In the matter of the Southern Link Inland Port

**STATEMENT OF EVIDENCE BY SIMON HENRY BLOOMBERG ON BEHALF OF
SOUTHERN LINK PROPERTY LIMITED**

WATER QUALITY

19 August 2026

Figure 1. Monitoring for parameters with toxicological effects

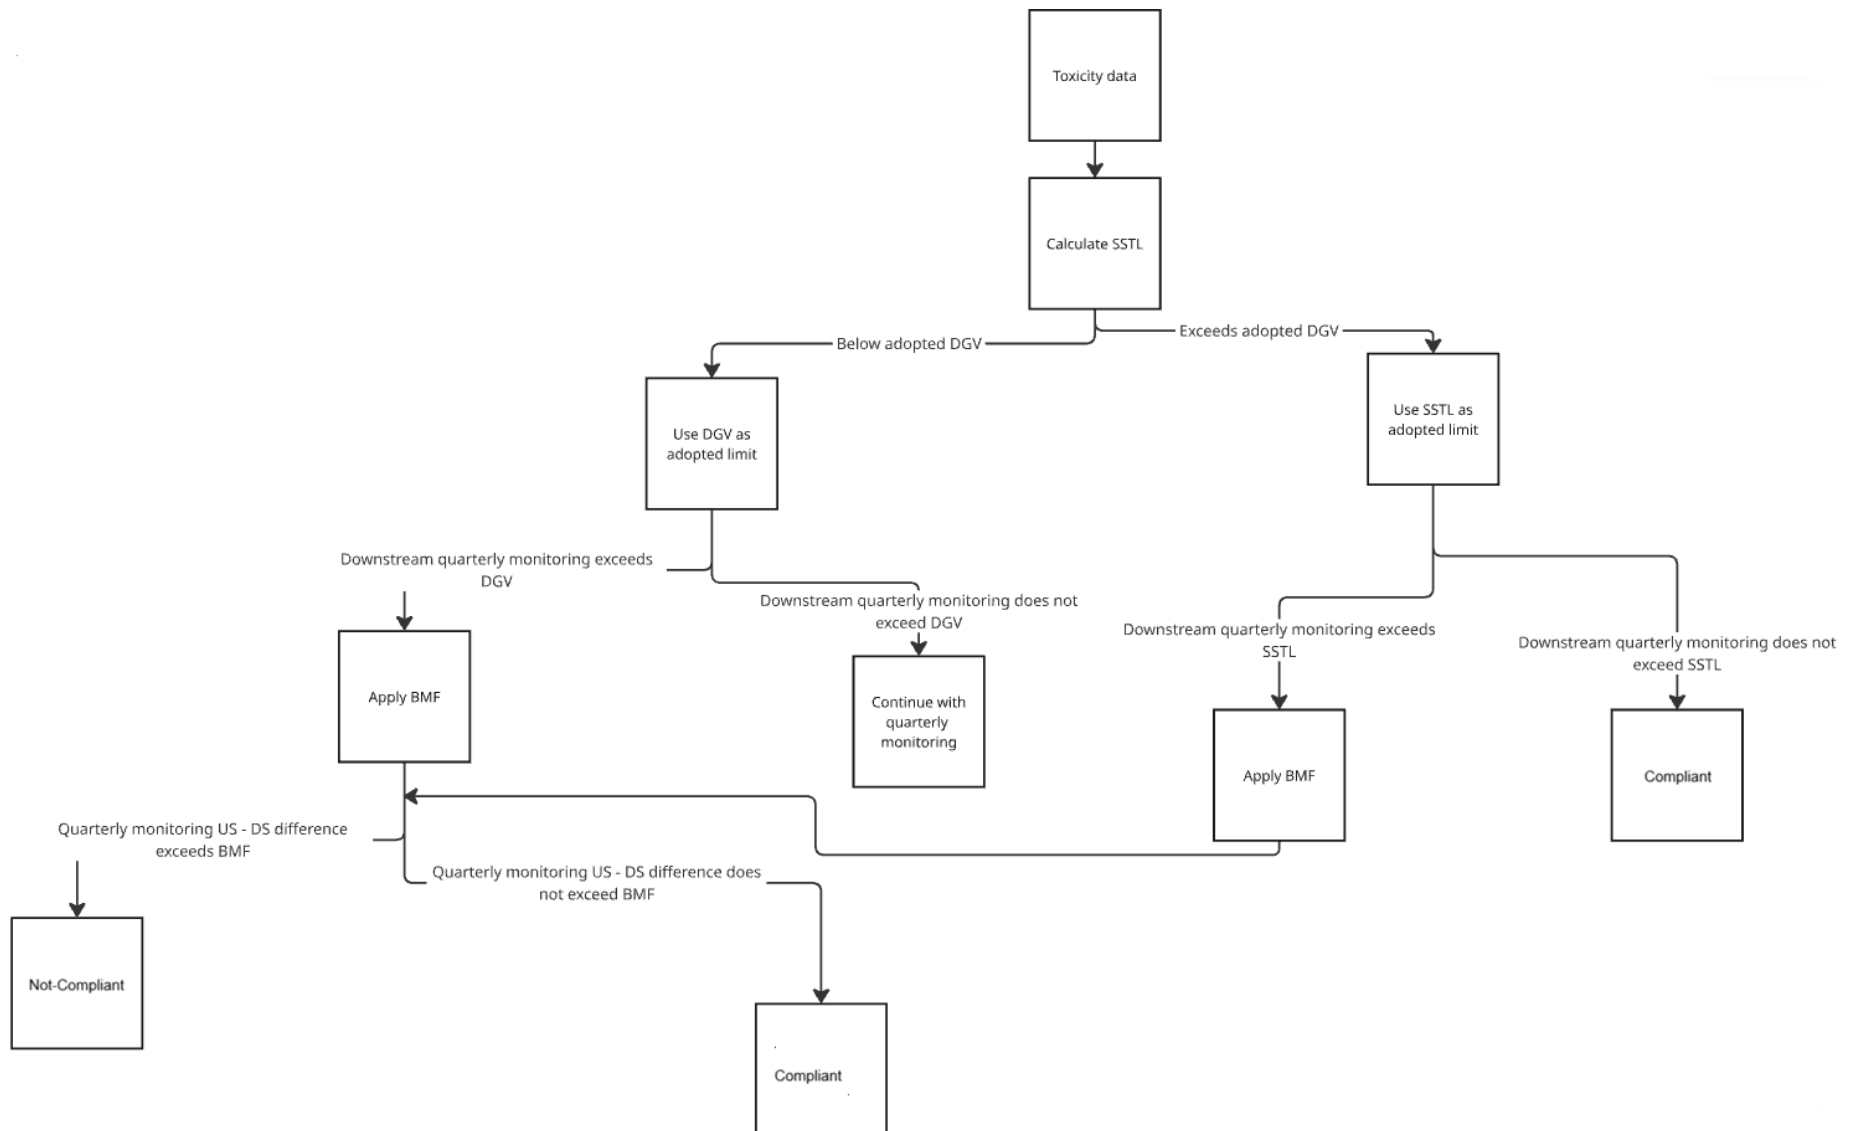
“...The applicant proposes the use of a baseline modification factor to account for natural variability. While this approach is generally appropriate, the basis for deriving the modification factor has not yet been established due to the limited baseline dataset currently available. The proposed methodology provides little detail regarding the statistical approach that will be applied to derive modification factors, determine trigger thresholds, or define meaningful change for different analytes.

“...The appropriateness of the proposed 10% trigger should be reviewed once a sufficient baseline dataset has been collected. To make sure that trigger values represent a detectable and meaningful change from baseline conditions, rather than normal environmental variation, this review should:

2.20 In the light of the matters raised by the ORC comments, I have undertaken a careful review of the proposed 10% and Baseline modification factor methodology. That work has identified that the approach may be difficult to implement and there is a risk that it may not meet the required statistical

robustness. For these reasons, I have revised the approach. The revised approach follows the recommendations of the ANZG water management framework, that is the use of the 80%ile of baseline dataset consisting of 24 or more reference condition samples. A description of the assessment methodology is set out in **Table 1**. The following definitions apply to the revised methodology:

2.21 To provide a clear framework for the assessment of the monitoring data for the purpose of assessing compliance, the following flow charts are provided (Error! Reference source not found.) and worked examples (**Table 2**). These charts present the process for determining a non-compliance and whether a monitoring trigger and response is required or not when concentrations in the downstream / compliance sample exceed the adopted DGV or SSTL for a given parameter (PC Stressor or toxicity).
